MetroLink Consultations  
Transport Infrastructure Ireland  
Parkgate Business Centre  
Parkgate Street  
Dublin 8, D08 DK10

Re: Metrolink Non-Statutory Consultation - May 2018

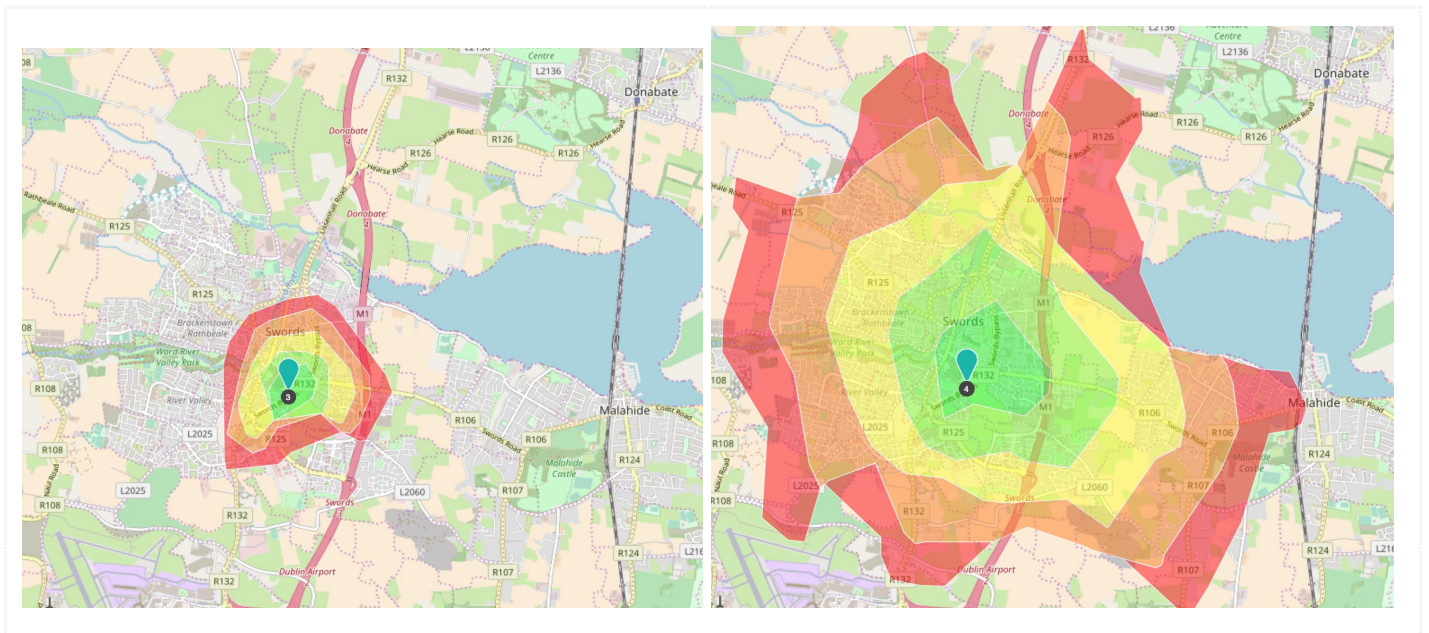
As outlined in the 'key facts' infographic the proposed project will potentially carry 15,000 passengers per hour at peak times, and overall the preliminary CBA is showing a highly acceptable greater than 2:1 ratio. But when similar transport investments in cycling are assessed they can provide a much higher rate of return, and can even have the potential to carry large numbers of commuters. For example, at this point in time, with very low levels of investment in city routes, over 12,000 cyclists are recorded as crossing the canal cordon on a daily basis during the morning peak. There is no doubt that for considerably less investment levels than MetroLink – approximately €0.5bn – this figure could easily be raised to 50,000, through provision of safe segregated routes. Furthermore cycling projects, mainly through the health benefits, reduction in carbon emissions, and journey time guarantees, regularly provide a very high Benefit:Cost ratio between 5:1 and 12:1. The potential role of cycling in supporting modal change and decreasing congestion can often be ignored by policymakers in favour of the more expensive and glamorous projects, although all are needed.

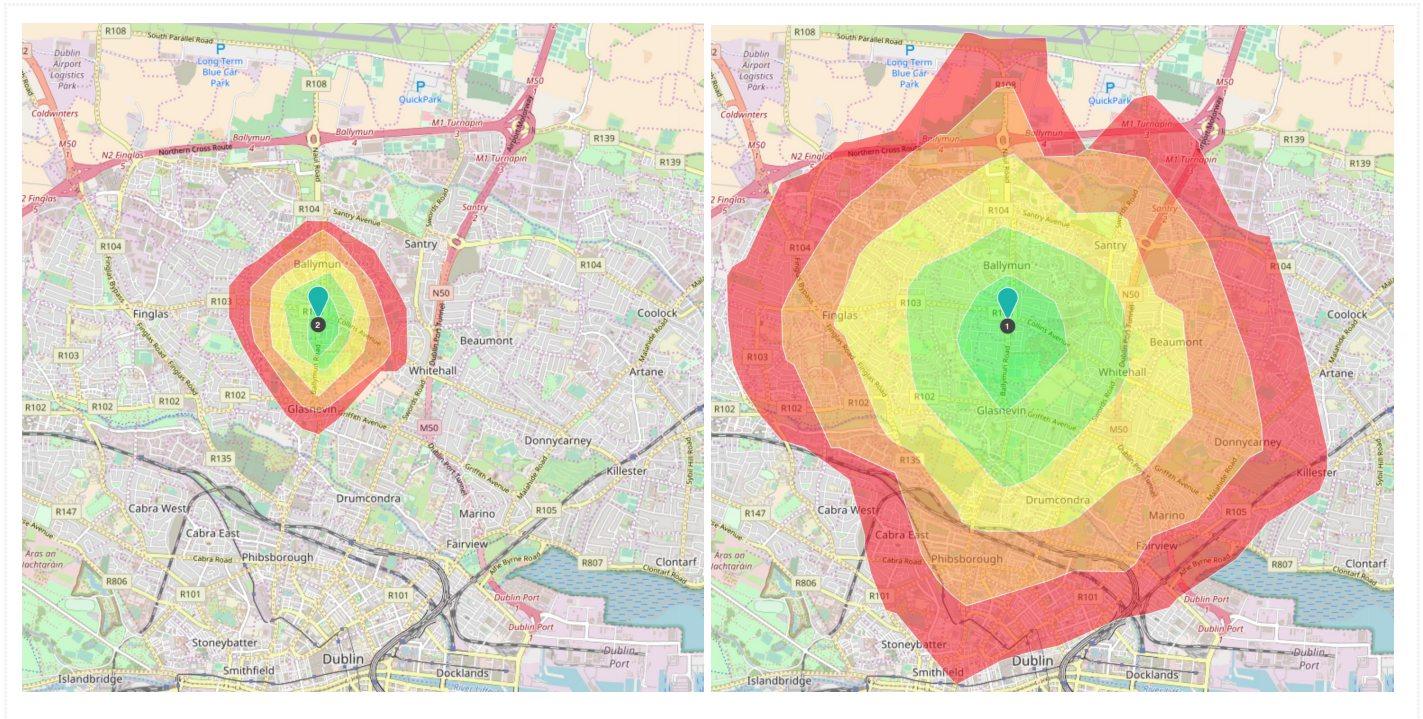
To demonstrate how significantly cycling can increase the catchment area of metro stops here are isochrones for walking and cycling 15 minutes from the Swords Central stop and the Collins Avenue stop. Each coloured bar of the isochrone is three minutes. The dark green is how far you can travel in 3 minutes, yellow is 9 minutes, and red 15 minutes. The walking pace is assumed to be 6km/h and the cycling max speed is assumed at 25km/h.

The Swords central stop is within 15 minutes cycle (right) of most of Swords and parts of Malahide. The 15 minute walking distance (left) from Swords Central has a much smaller catchment area that doesn't cover any of the residential hinterland of Swords.

For the Collins Avenue stop we're more interested in how much further east and west you can cycle (right) than walk (left) as there are metro stops directly north and south of the Collins Avenue stop. Cycling can provide for sustainable orbital movements necessary for people off the metro corridor to connect to the metro line.
